This meeting of the Grimes Planning and Zoning Commission was called to order Tuesday January 7, 2020 at 5:30 P.M. at Grimes City Hall.

The Development Services Department is in receipt of a proposed Site Plan for Destination Market Plat 4. Based on the review of the provided submittal materials, staff have the following comments:

Planning & Zoning Staff Report

The Development Services Department is in receipt of a proposed Site Plan for KinderCare. Based on the review of the provided submittal materials, staff have the following comments:

Sheet C101

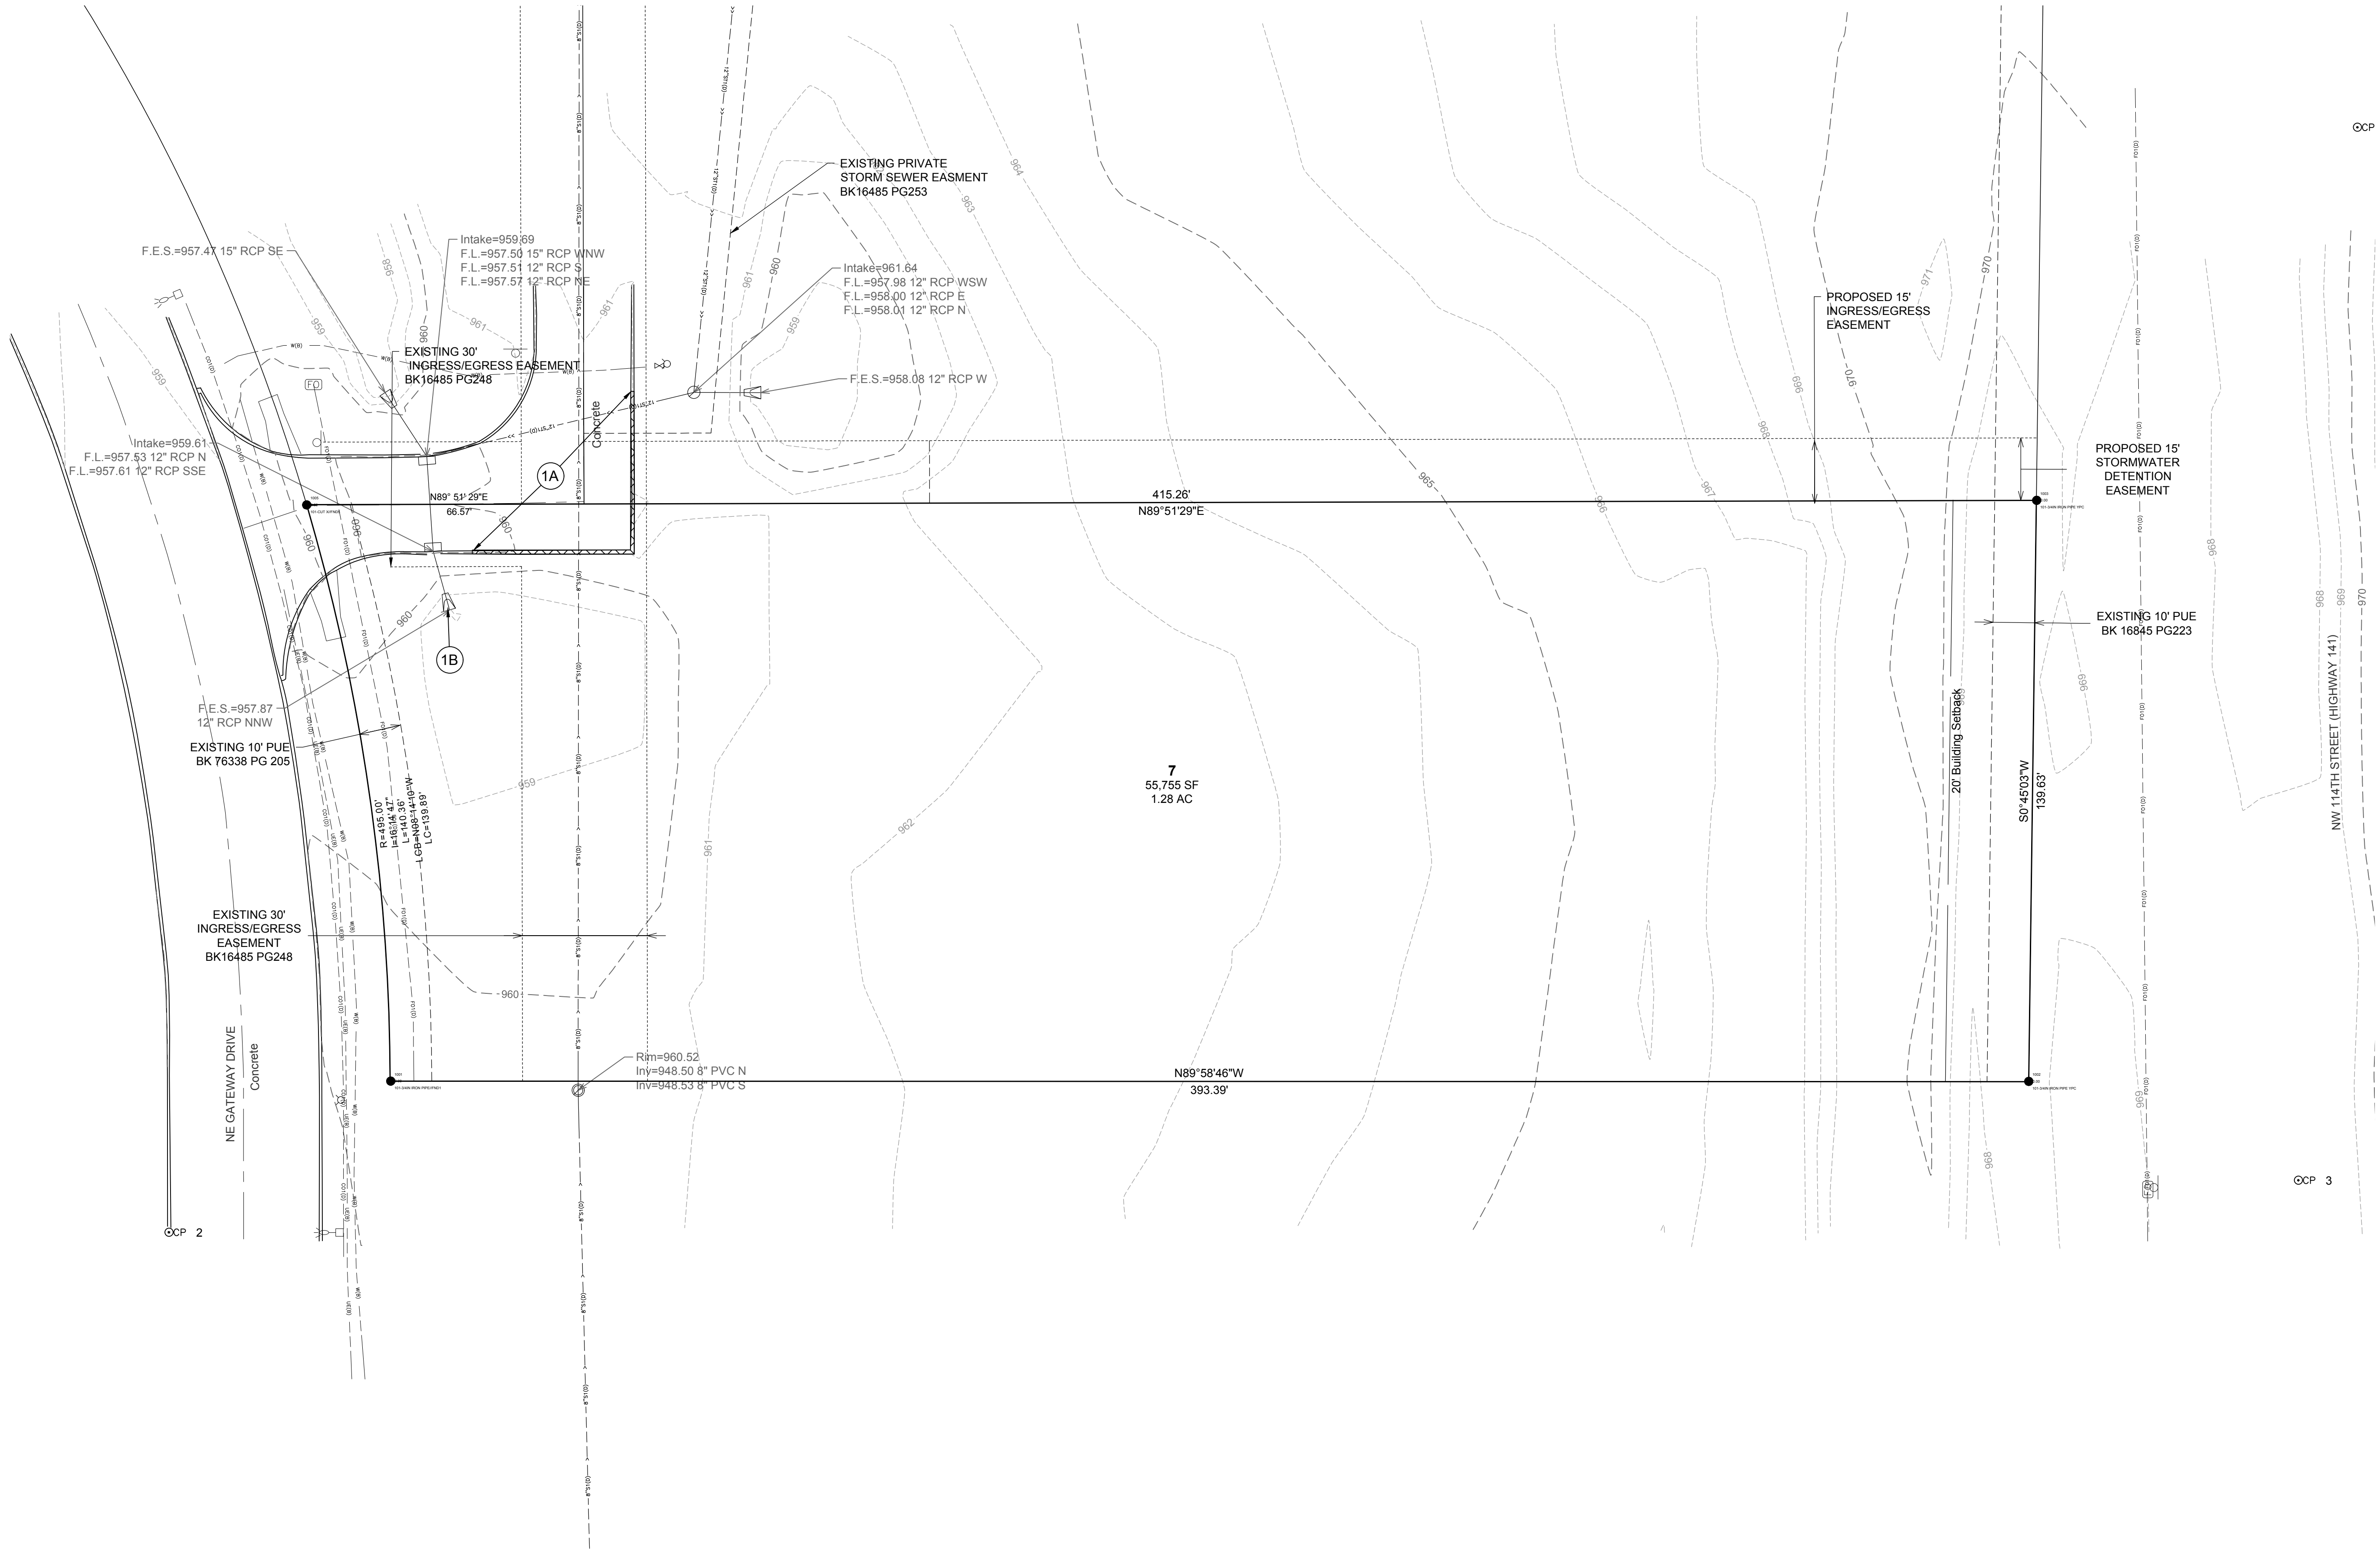
4. Please revise the utility contact information from City of Johnston to City of Grimes.
Contact still refers to Johnston.
5. ~~Please note under property description that the property is subject to Plat review, and note the new final plat name; Heritage at Grimes Commercial Plat 3, Lot 3.~~
6. ~~Please revise the Zoning to R-4, Heritage PUD.~~
7. ~~Please identify the proposed occupancy of the daycare.~~
8. ~~Please revise the setbacks per the Heritage PUD (FY = 20', SY = 0')~~
9. ~~Please update the general notes (attached)~~

10. Please include the required vs provided open space figures. **Required open space is 25%. Staff questions what was called open space.**

Sheet C200

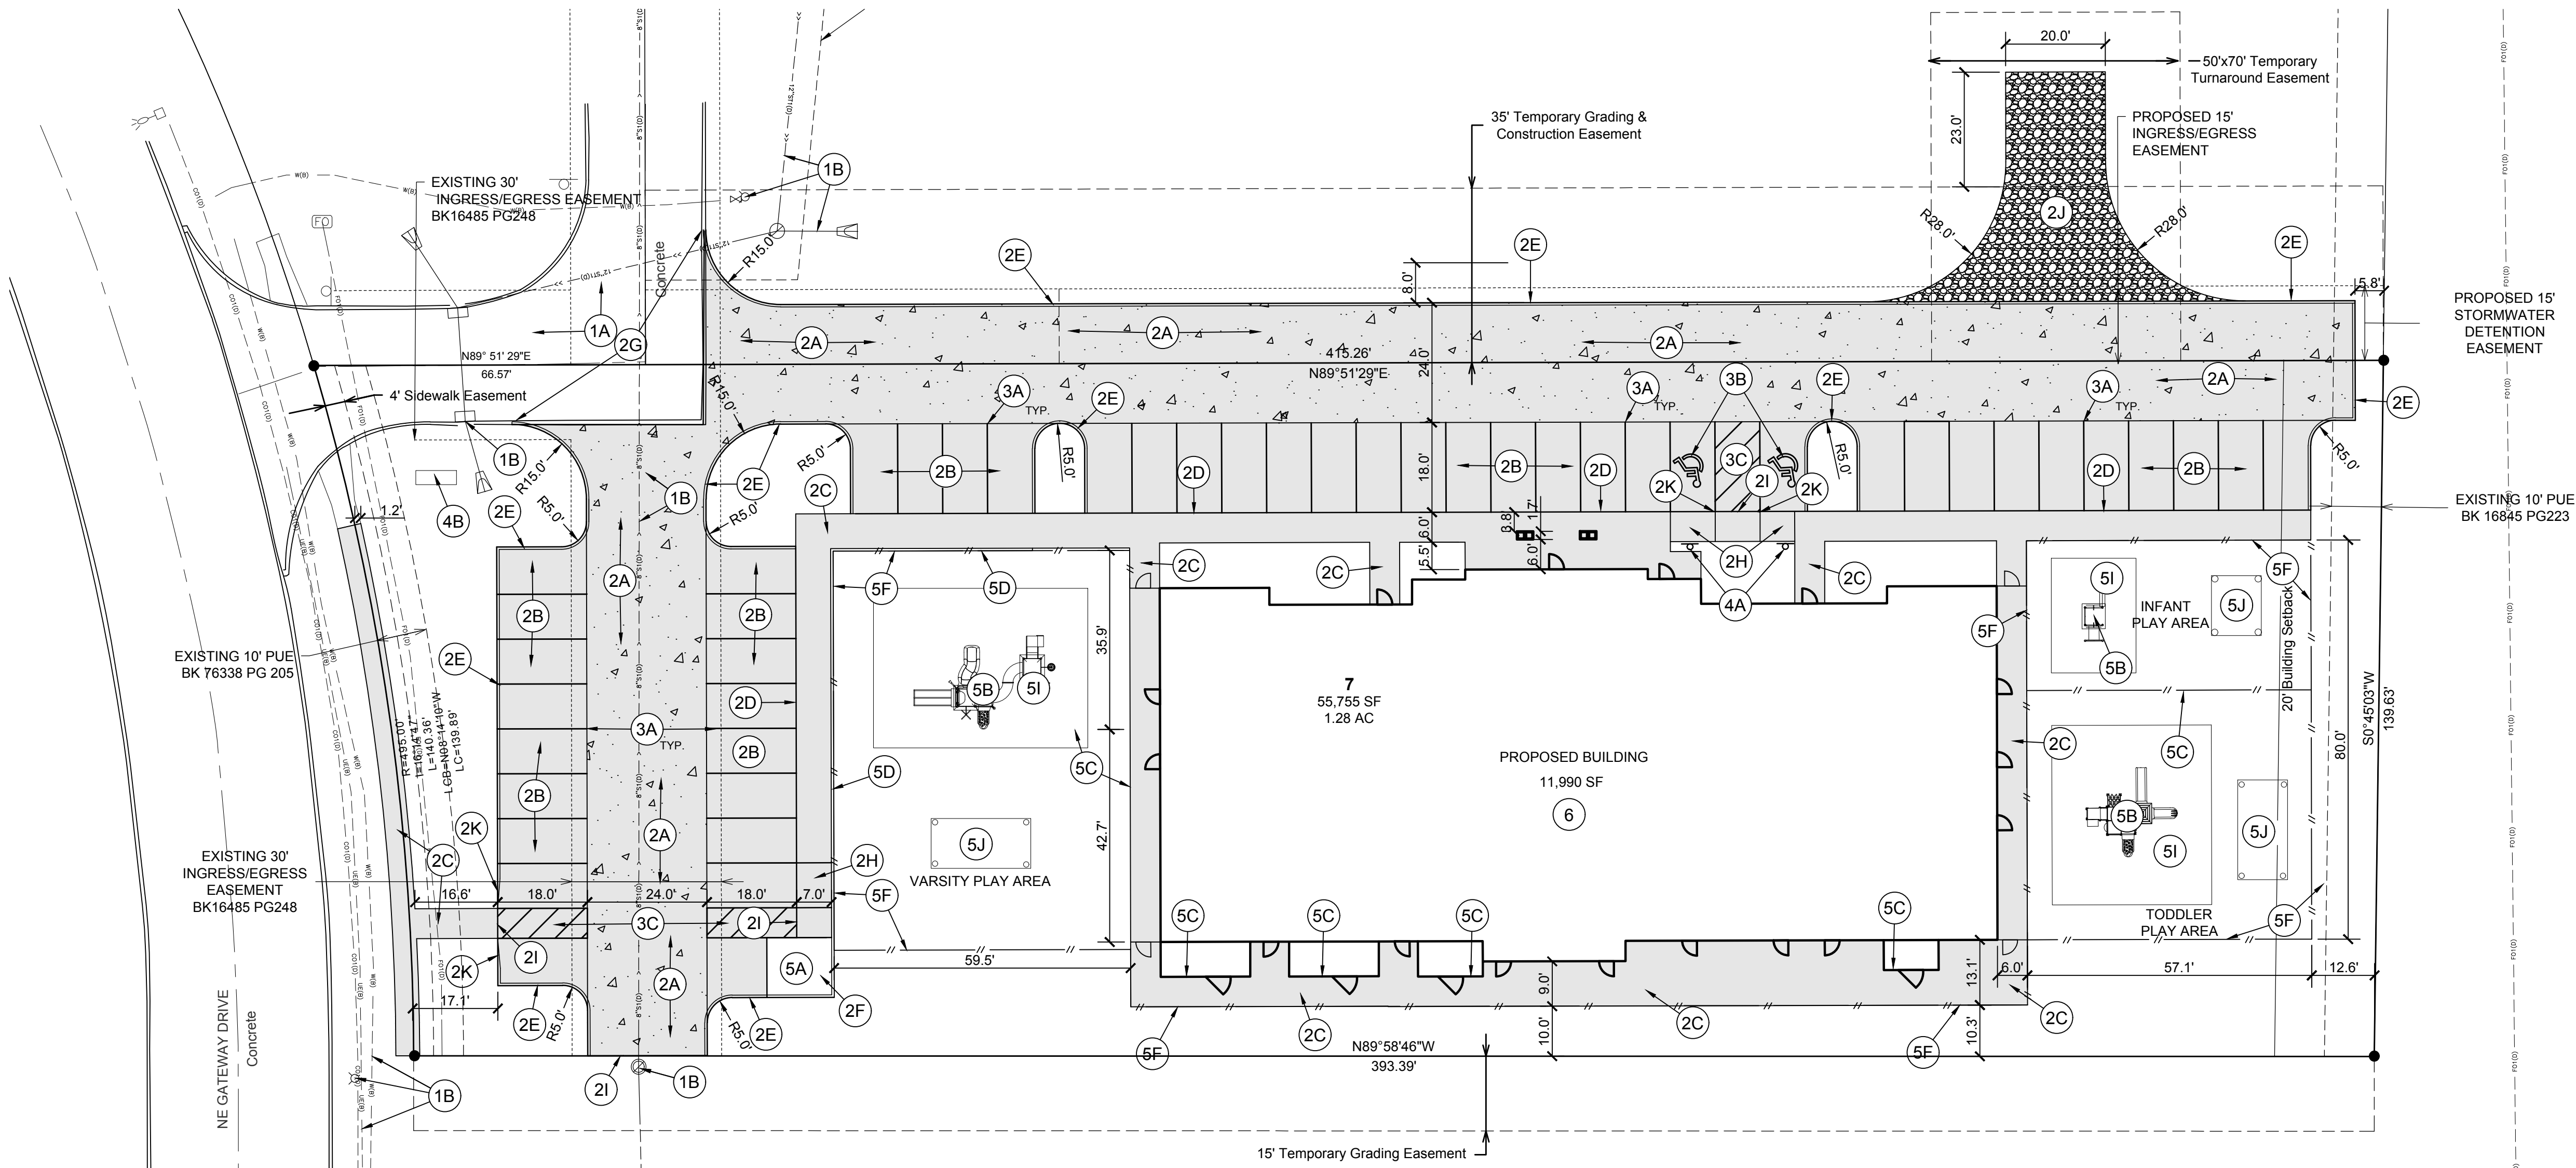
- ~~11. Please include the removals and/or relocates on the existing conditions page.~~
12. **Staff questions if grinding the curb is adequate in this case, or if it should be saw cut and removed.**

Sheet C400

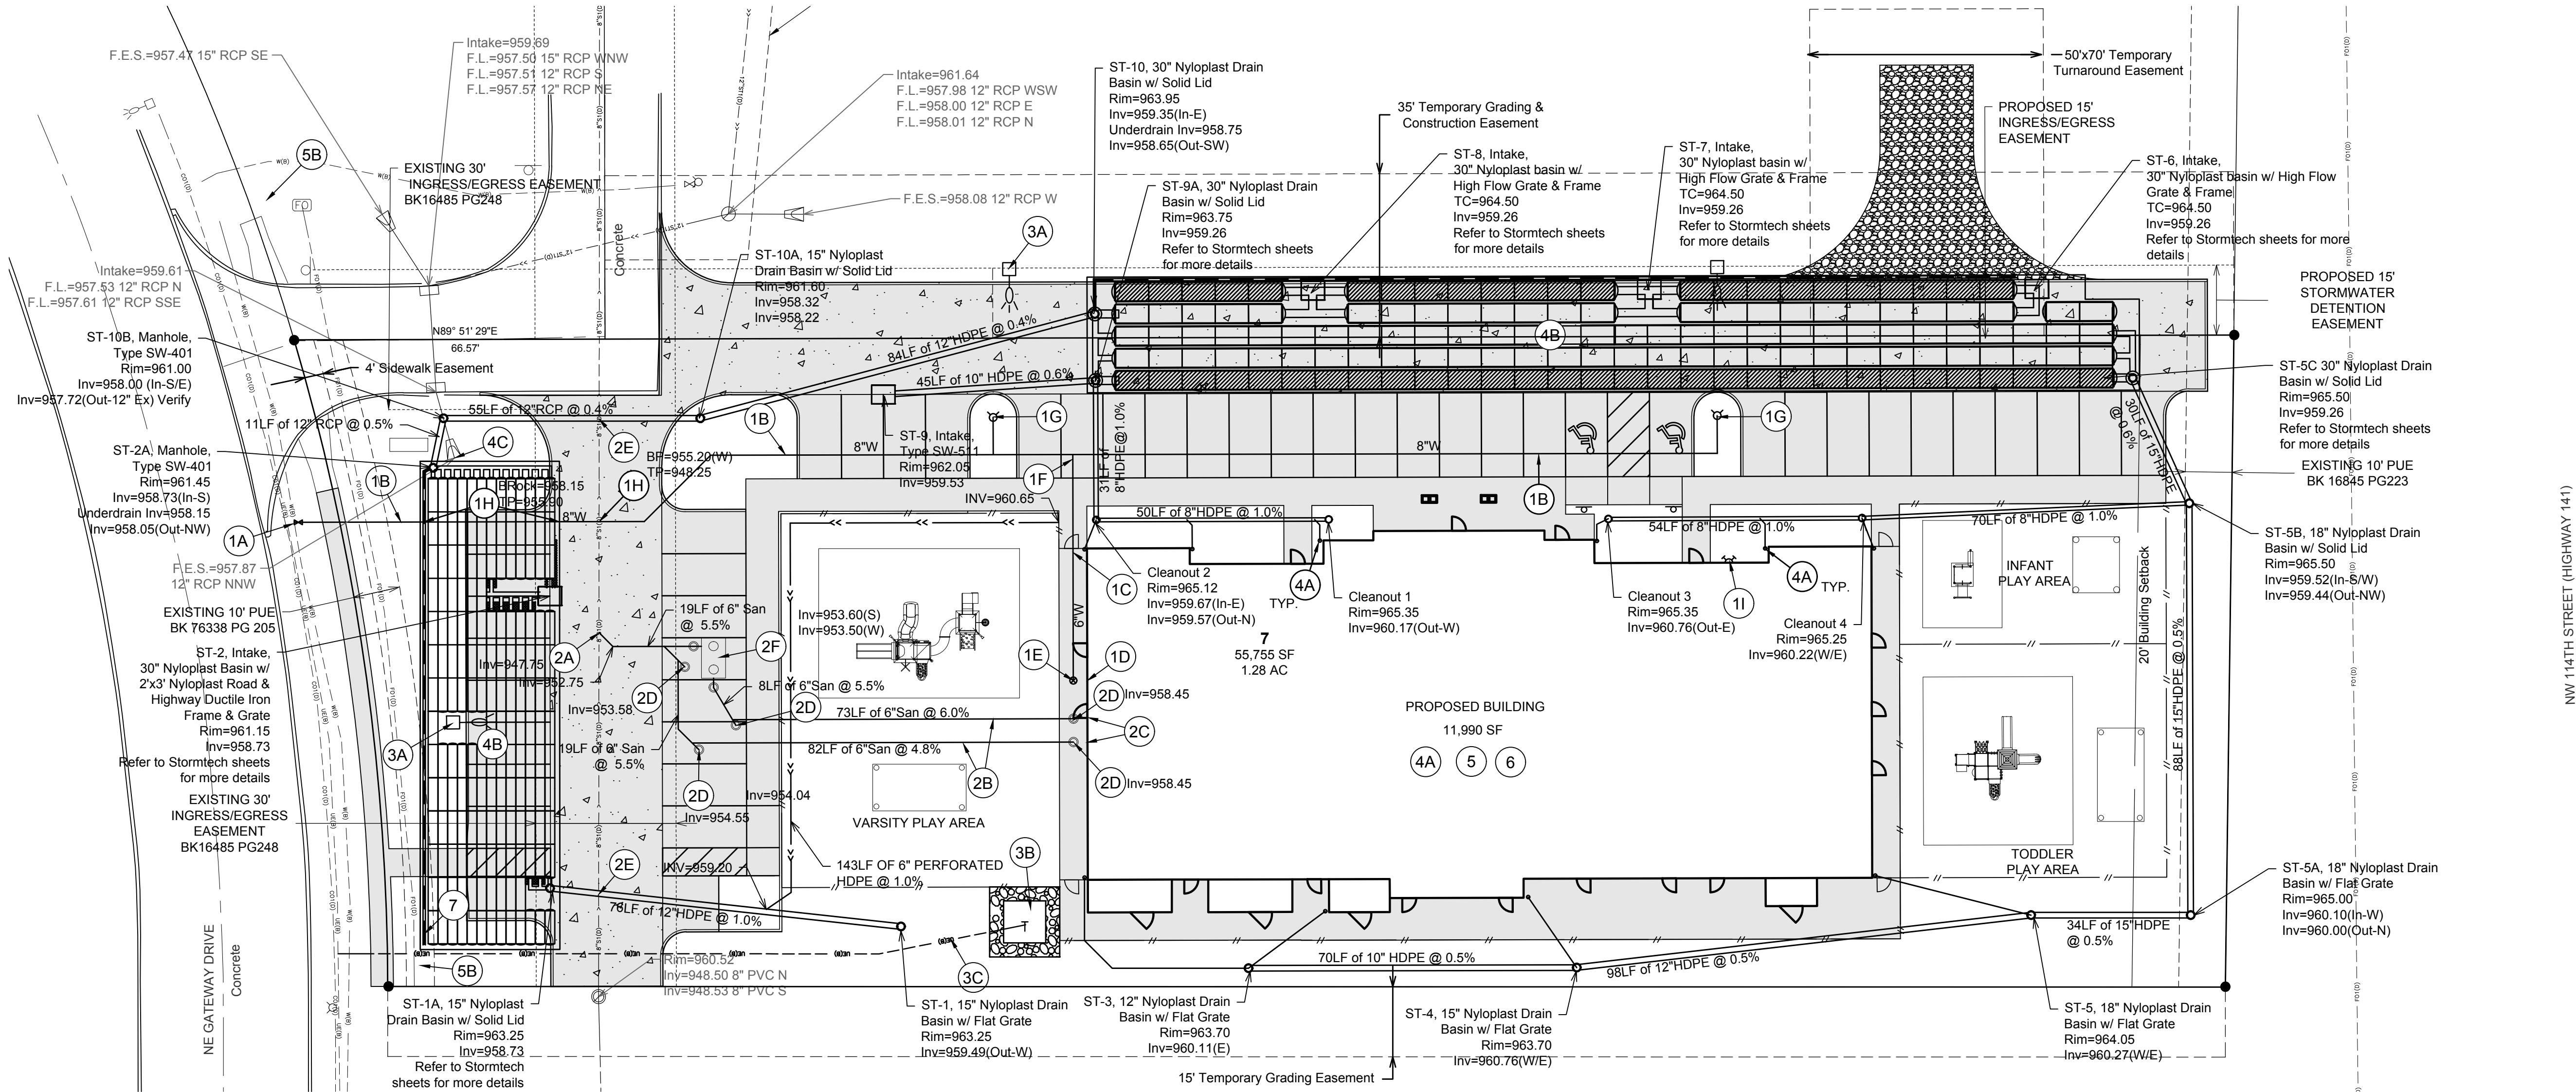
13. Please provide the off-site temporary grading easement documents. **Provide when available.**
- ~~14. Please show a public sidewalk easement along the frontage of NE Gateway Drive where the sidewalk comes onto private property.~~
- ~~15. Please provide a radius there the new pavement extends from the existing driveway. The turn should not be terminated with a 90 degree.~~
- ~~16. Staff would suggest moving the accessible stalls west to be closer to the main entrance.~~
- ~~17. Please adjust note J to require the turnaround to be paved.~~
- ~~18. Please indicate the cladding on the retaining and note that it should match the principal building.~~
